Re: Pivot Energy Solar (#1544888)/Pre-Application Meeting held June 03, 2021

STAFF COMMENTS - PRE-APPLICATION MEETING

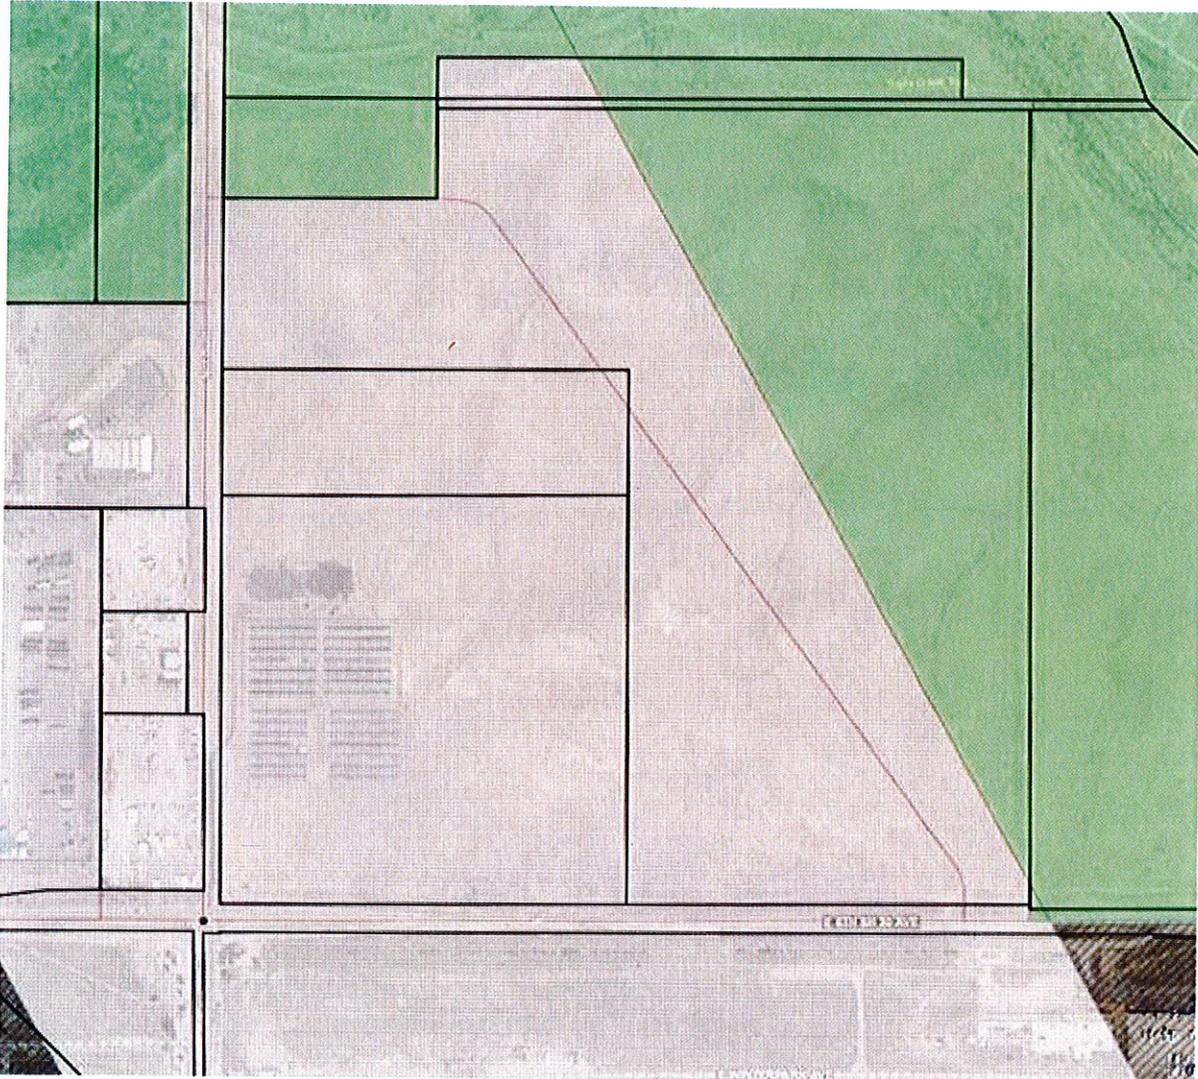
Below is what the zoning map shows in terms of zoning boundaries (grey is APZ, green is POS). If you build in the POS zone, you will be subject to the POS zone standards/requirements but if not, you will just be subject to APZ. The PROS 25' special landscape buffer is the only buffer requirement I know of for POS. Please reference Table 4.2-4 in the Unified Development Ordinance for a comprehensive list of dimensional standards in APZ and POS. I hope that helps – I'm happy to answer any other questions you may have.
